DEVELOPMENT REVIEW COMMISSION STAFF REPORT

CASE NO.: 22-32000003 PLAT SHEET: M-22

REQUEST: Approval of a special exception and related site plan to construct

a self-service express car wash.

7. ALL DISTURBED AREAS INCLUDING ROW SHALL BE SODDED.

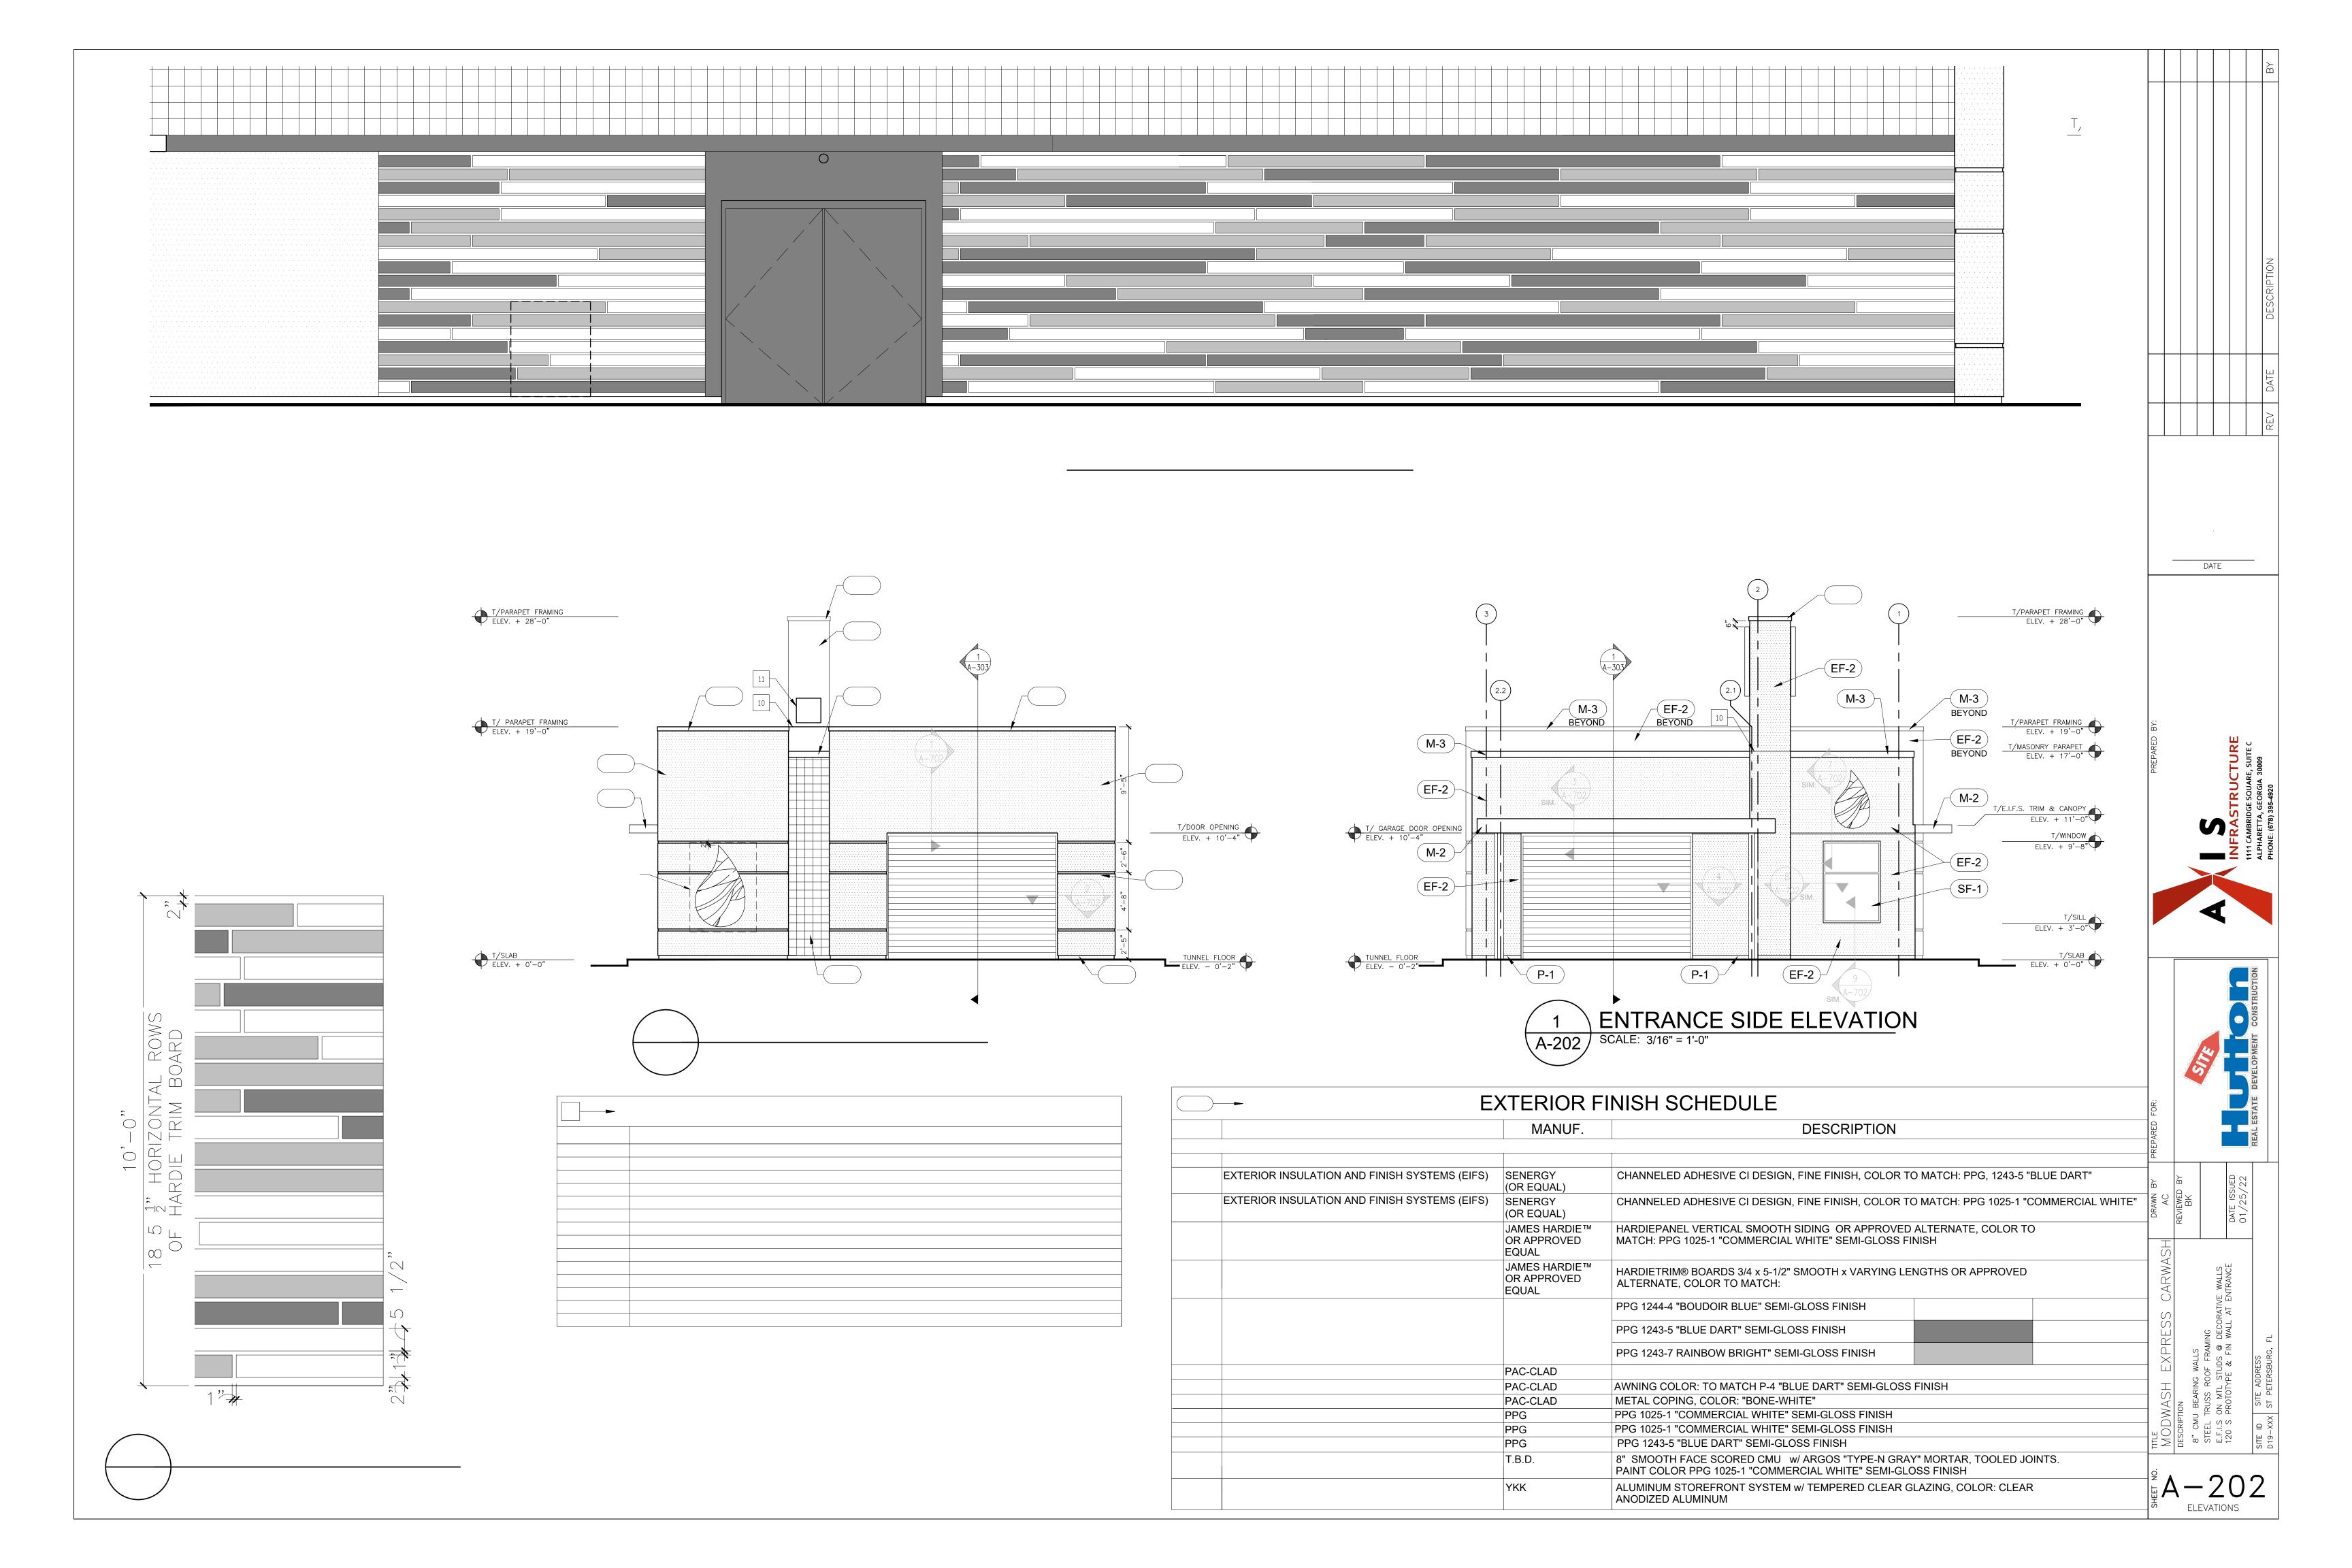
- 9. A minimum of 84 specimen inches shall be preserved on-site as required by Section 16.40.060.2.1.3. The tree disposition plan included with the application notes only 73 specimen inches to be preserved.

- 10. Shrubs shall be installed around the exterior perimeter of the ponds.
- 11. The parallel parking spaces shall have a minimum length of 23 feet.
- 12. The dumpster compound shall have opaque gates.

- 15. Bicycle parking shall comply with Section 16.40.090.4.1.
- 16. The transformer shall not be visible from ROW. The applicant shall relocate or provide decorative screening to shield from view.

Section 16.20.090.7 of the City Code notes that emphasis is placed on creating a positive experience for the pedestrian, which is the base of the transportation hierarchy. The sidewalk pavement on 39th Avenue North shall be continued through the driveway to clearly delineate the pedestrian network. The driveway on 40th Avenue North should be designed to discourage wrong-way entry from 40th Avenue North. If you have any questions about this memorandum, please call me at (727) 893-7151.
